Notice of Alteration Form

Client File No. : 4412		Environment Act Licence No. : 2482R	
Legal name of the Licencee: Rural Municipality of Ritchot			
Name of the development: Ritchot Class 1 Waste Disposal Ground			
Category and Type of development per Classes of Development Regulation: Waste Treatment and Storage                                      Class 1 Waste Disposal Grounds			
Licencee Contact Person: Mr. Steve McCabe, MidCanada Environmental Services			
Mailing address of the Licencee: 1090 Kenaston Blvd.			
City: Winnipeg		Province: MB	Postal Code: R3P 0R7
Phone Number: (204)987-9600      Fax: (204)987-9601      Email: smccabe@gfenv.com			
Name of proponent contact person for purposes of the environmental assessment (e.g. consultant): David Ediger, D. Ediger Consulting Services			
Phone: (204)771-4245		Mailing address: 296 Baltimore Road, Wpg, R3L 1J1	
Fax:			
Email address: dedigerconsulting@mymts.net			
Description of Alteration ( <i>max 90 characters</i> ): Removal of centre berm within landfill and increase in finished height to 12 metres

Notice of Alteration – R.M. of Ritchot Waste Disposal Ground,  
Environment Act Licence No. 2482R

# FIGURE 1

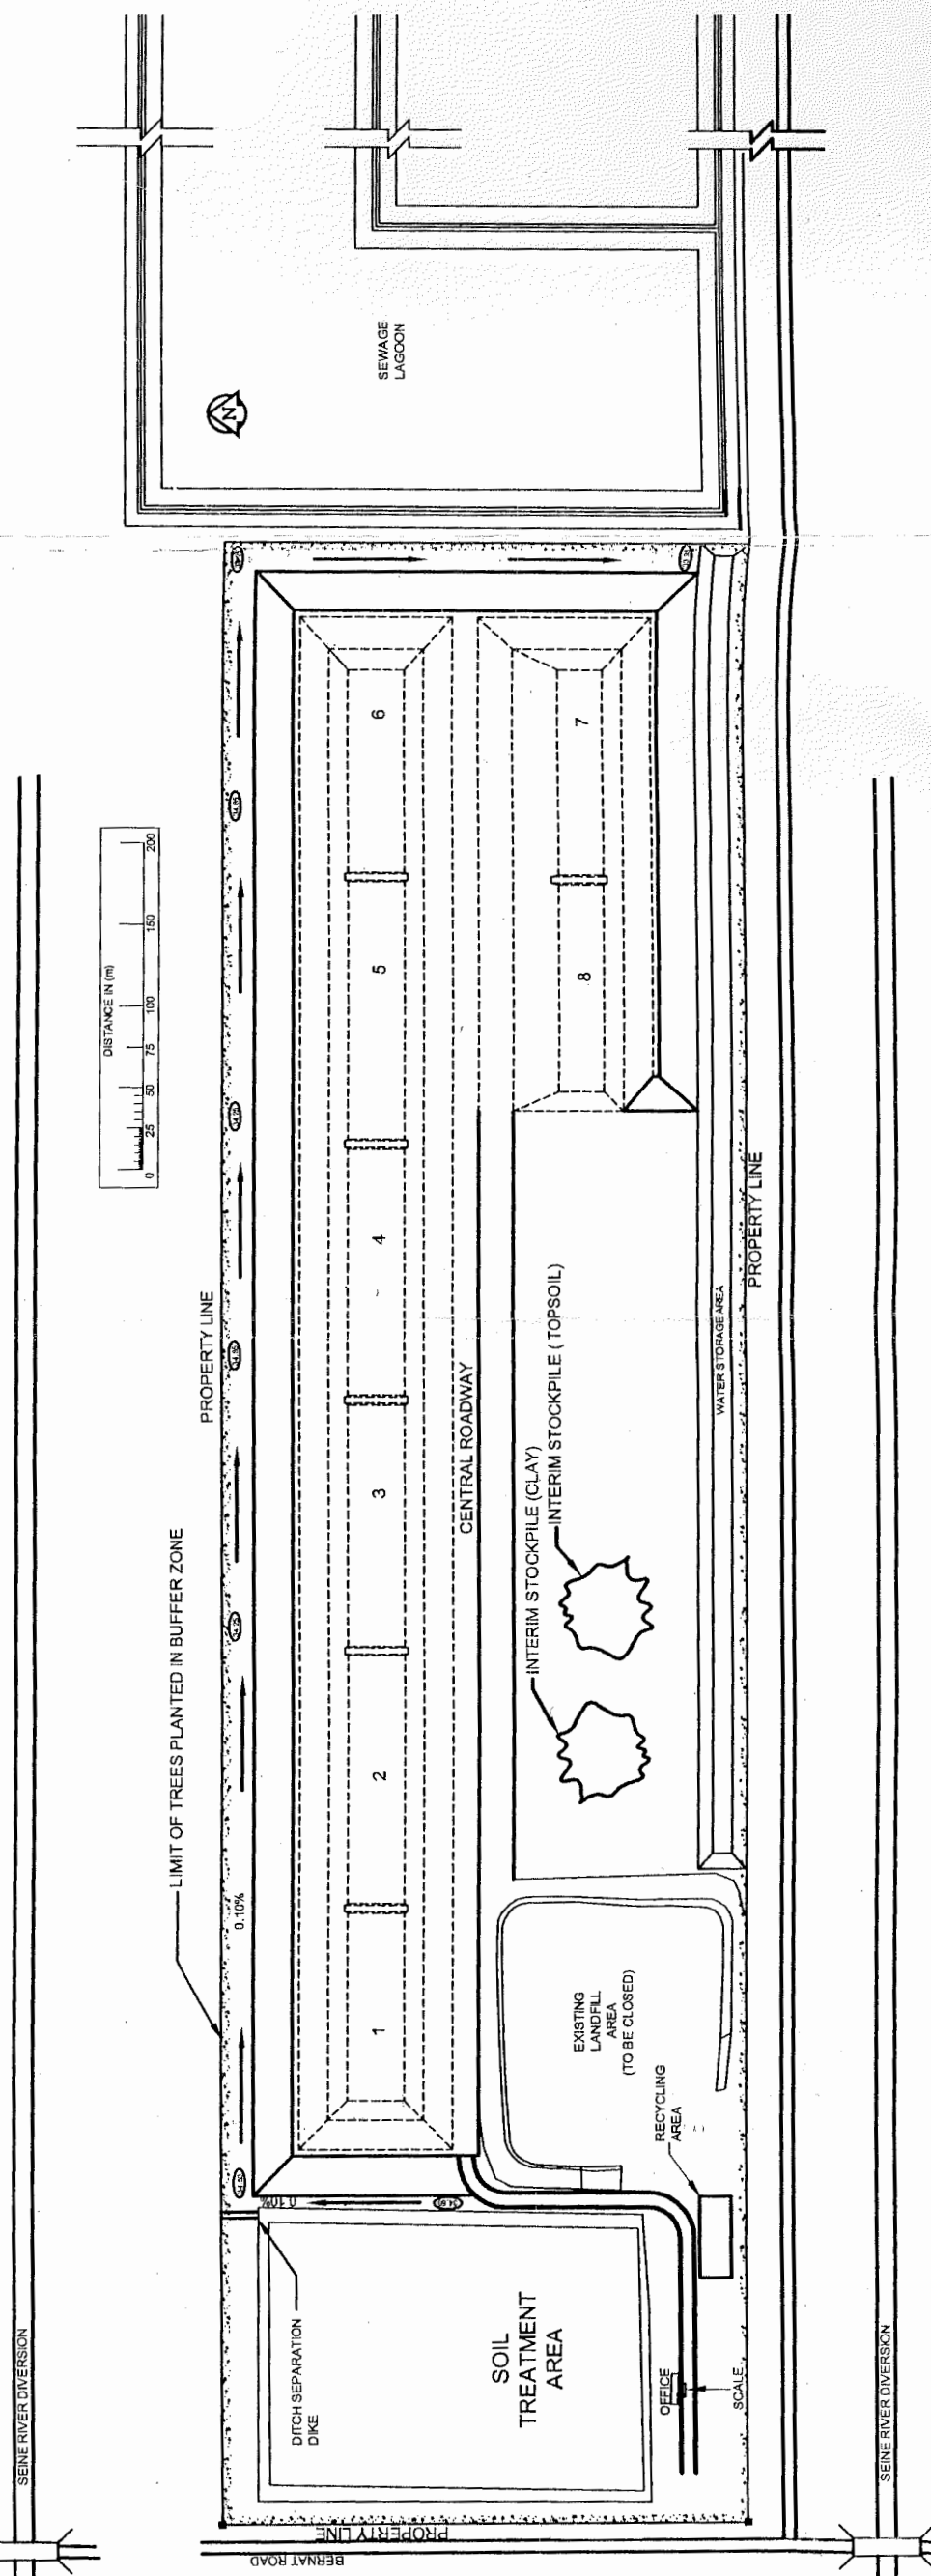
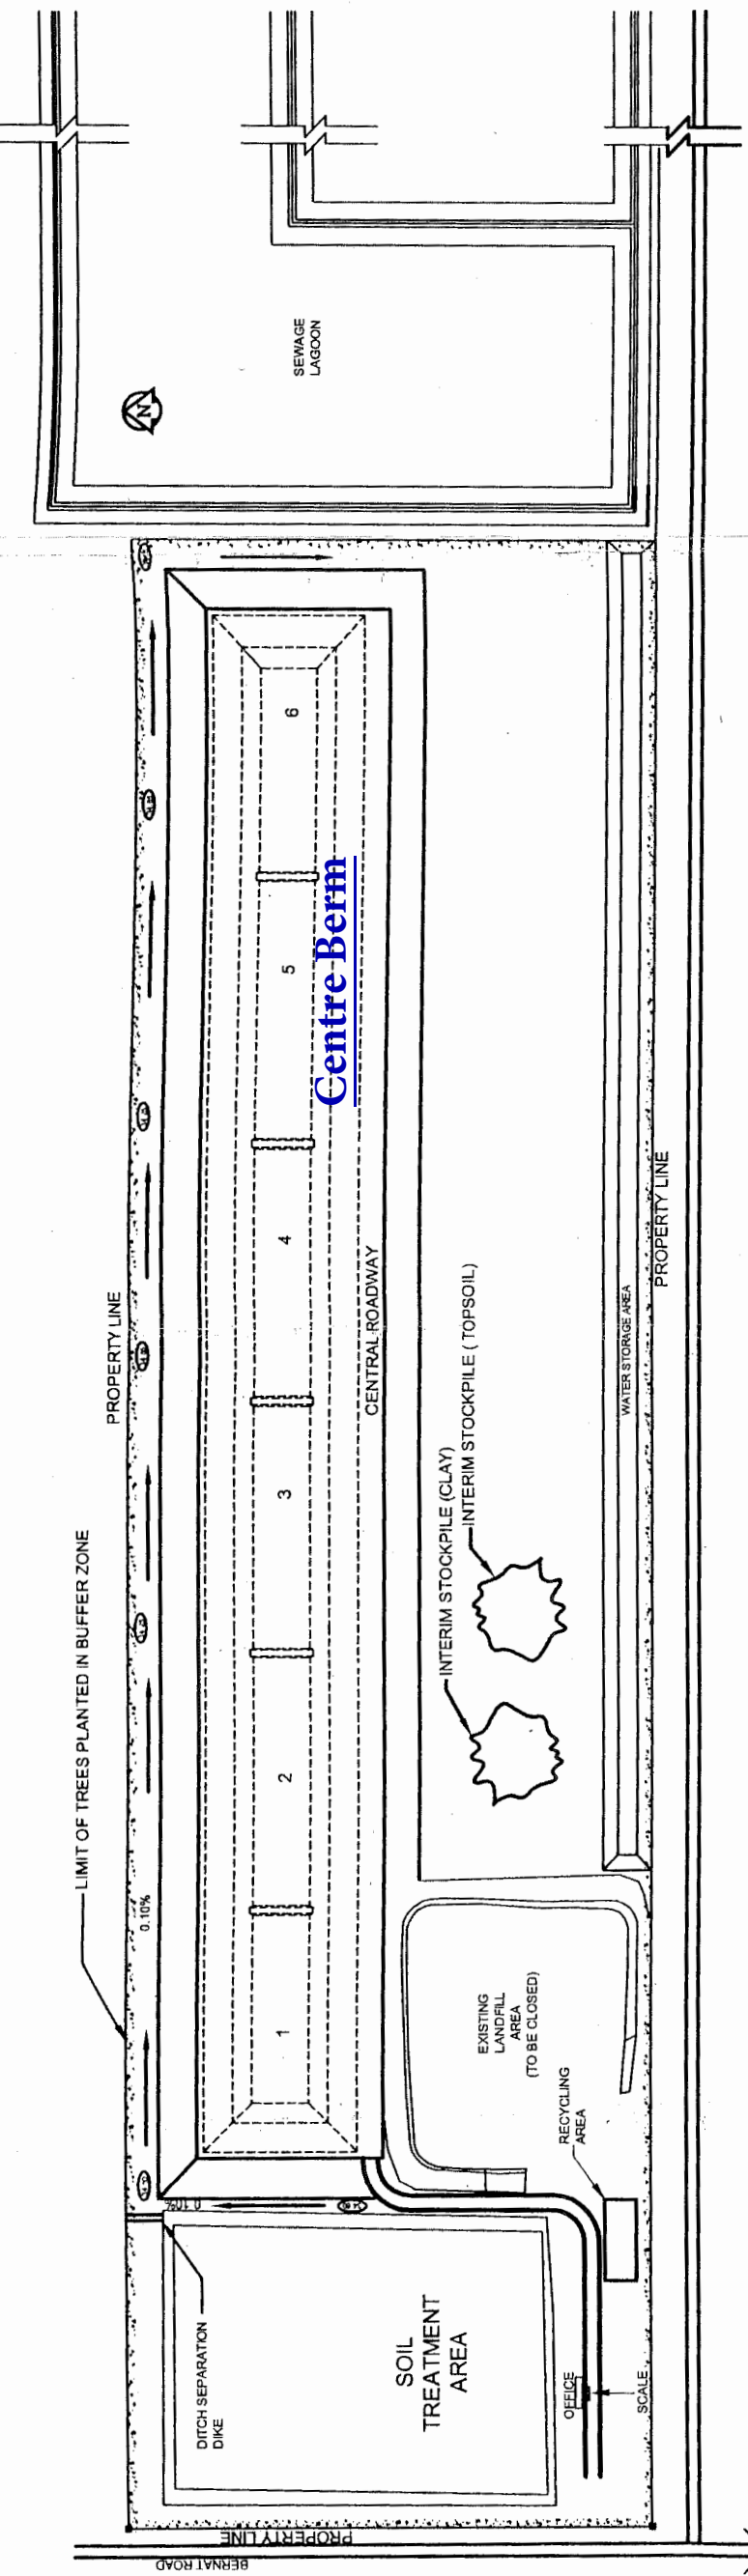
The original Environment Act Proposal included detailed design documents and drawings, dated July and August 2000, which contained the specifications for the construction of the individual landfill cells. The original design included an earth berm built to six metres above grade along the east-west centre line of the site, with cells being developed on either side of the berm. The plan view of the original cell configuration is shown in Figure 1. As indicated in the figure, cells were to be separated on the east and west sides by berms constructed to prairie grade, while the north and south sides were enclosed by berms constructed to an elevation of six metres above grade. Although a record of the rationale for including the centre line berm in the original design could not be located, MidCanada personnel have indicated that it was intended to provide a solid road base for accessing the landfill cells.

- The elevation of the berm, shown on Figure 1 as being situated down the centre of the facility in an east-west direction, be reduced from six metres above grade to prairie grade elevation.
- The maximum completed elevation of the cells, including final cover be increased from eight metres to twelve metres above prairie grade.

DATE:	NOVEMBER 2016
PROJECT NO.:	WX0469016
REV. NO.:	A
FIGURE NO.:	FIGURE 2

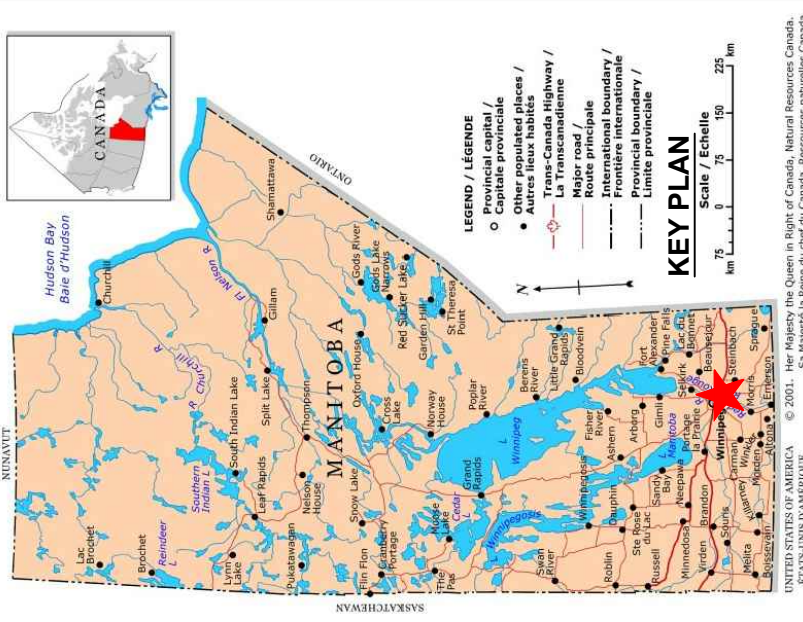
The revised design for the landfill cell is shown in the drawings identified as AMEC Figures 1 to 5. Cell 7, which is currently under construction, is used as the example in the detail drawings. In this instance, the north berm is constructed to six metres above grade as per original design. The south berm is proposed to be sloped from the cell base to approximate prairie grade level. The top of the east and west interior berms are at prairie grade as per the original design. Cell 6, which is immediately to the south, has the six metre berm on the south side. The completed profile of the two cells is illustrated in AMEC Figure 2, with Cell 6 on the left side of the separator berm and Cell 7 on the right.

The proposed completed profile of the landfill is shown in AMEC Figure 2. The covered waste will slope upward from the top of the perimeter berms on the north and south sides of the landfill to the centre road. The slope will be 10:1 or less. Prior to applying the final compacted clay cap, the area over the cells will be leveled and shaped to ensure that the twelve metre limit is not exceeded.

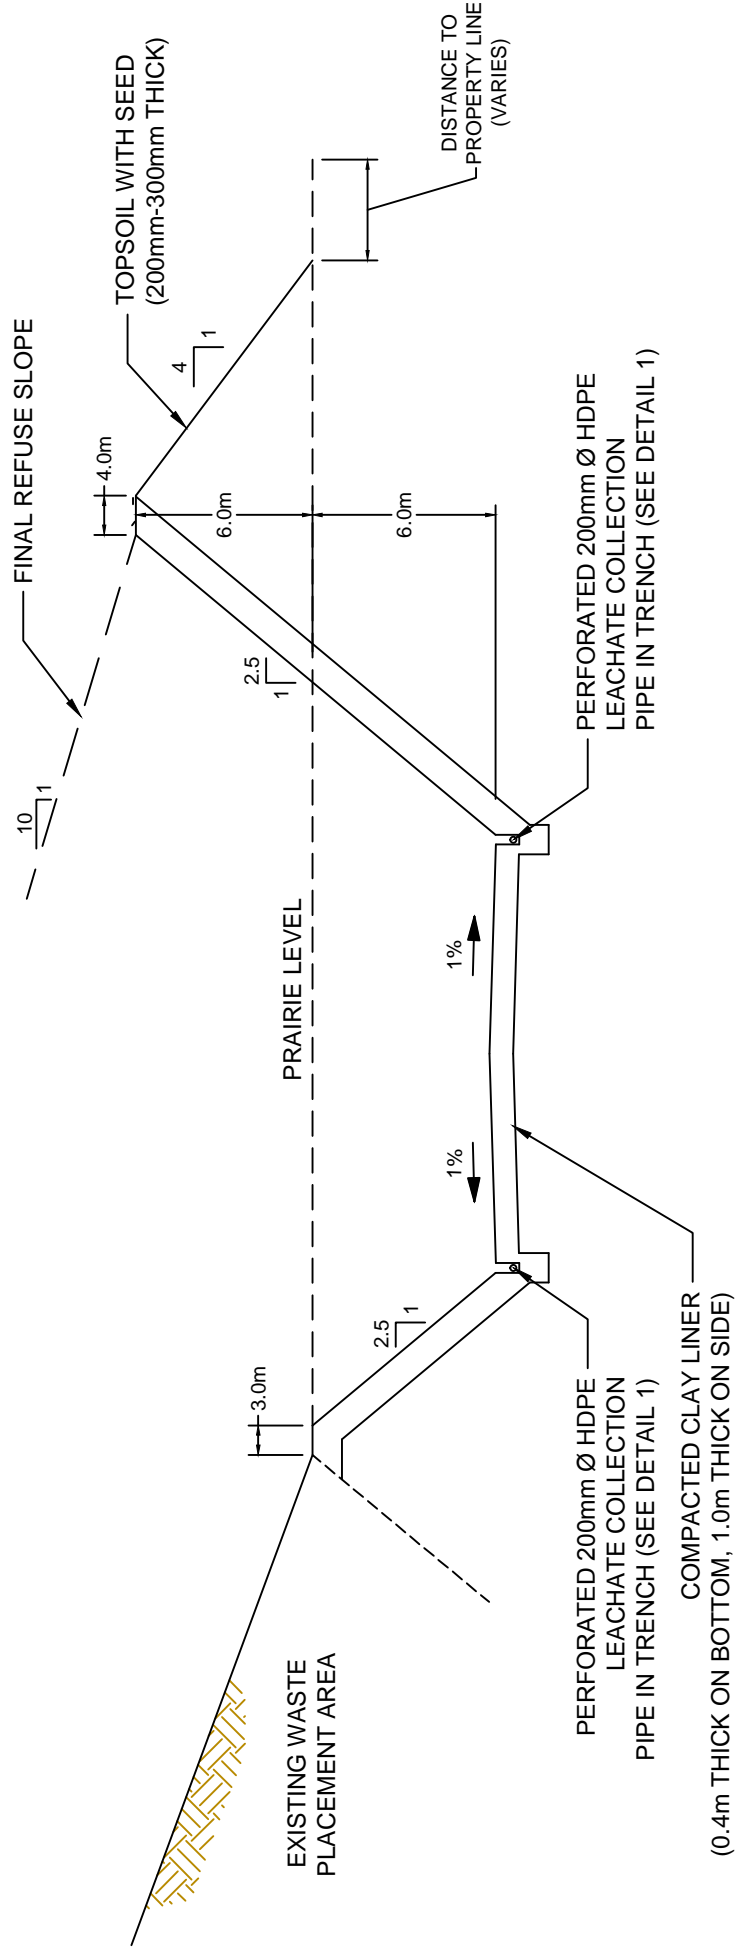
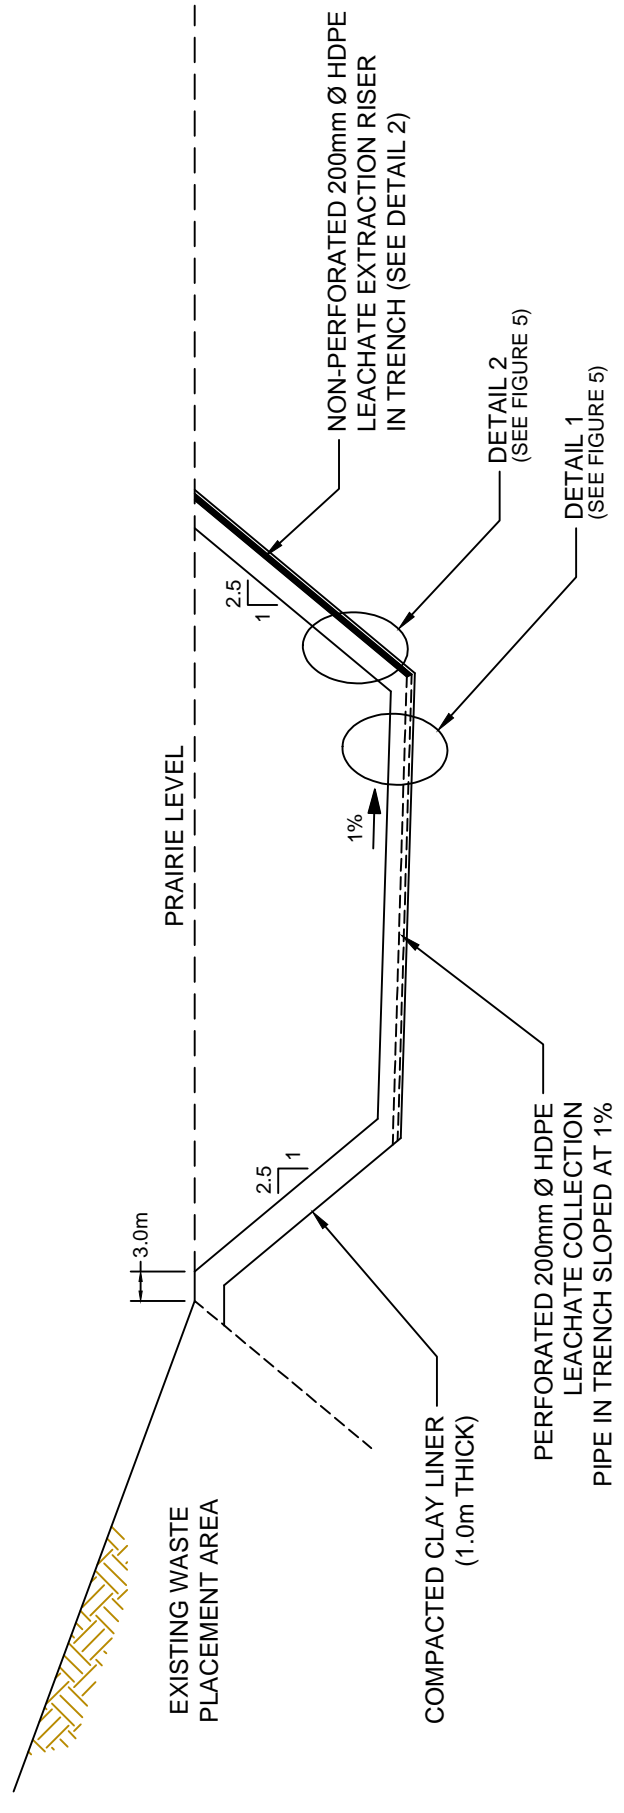
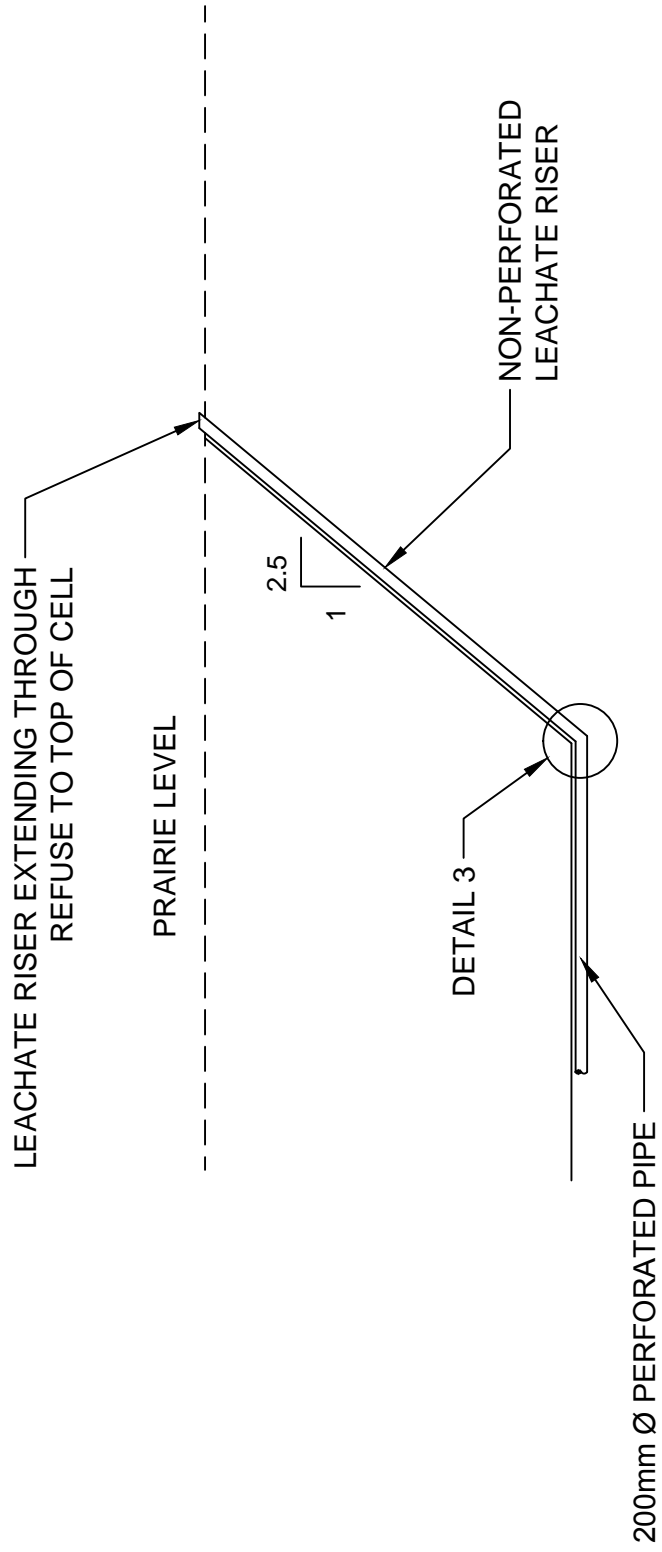
All surfaces within the cell incorporate a compacted clay liner as indicated on AMEC Figure 4. The specifications for the liner system are consistent with the original design and comply with the construction requirements in Licence 2482R.

The leachate collection system will remain essentially the same as in the original proposal. Details of the leachate trench and collection system are shown in AMEC Figures 4 and 5. All leachate risers will be constructed up the east slope of the respective cells.
